FINAL ENVIRONMENTAL IMPACT STATEMENT

**Cushman Hydroelectric Project
(FERC Project No. 460), Washington**

**APPENDIX A RESPONSE TO DRAFT EIS
COMMENTS**

Figure C-1. Potential anadromous fish habitat upstream of the Cushman project.

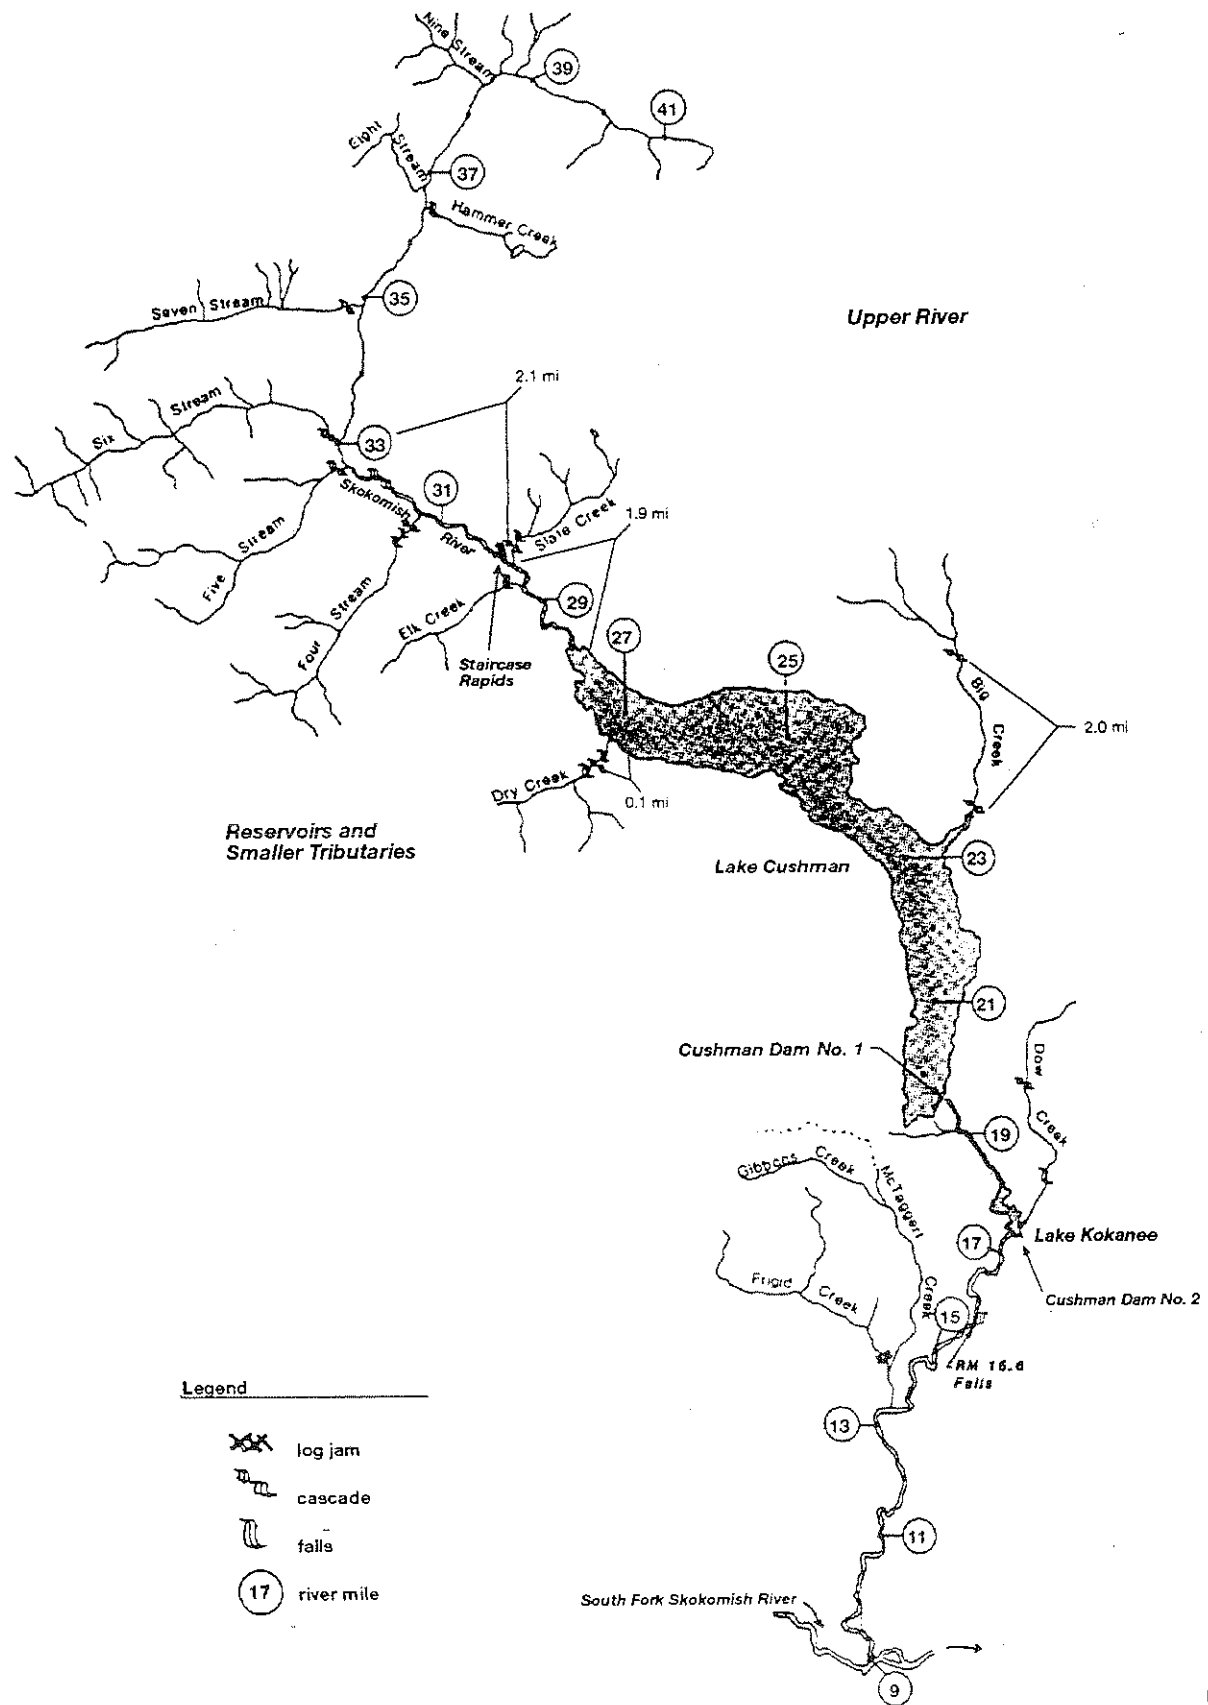
Page C-4, Table C-1: The Richert Farm should be analyzed separately from commercial timberlands in the Lower North Fork, and shown in Table C-1, C-2, C-4, C-5, C-6 and Figure C-1. Resulting changes in the Southern Lower North Fork parcel should also be shown.
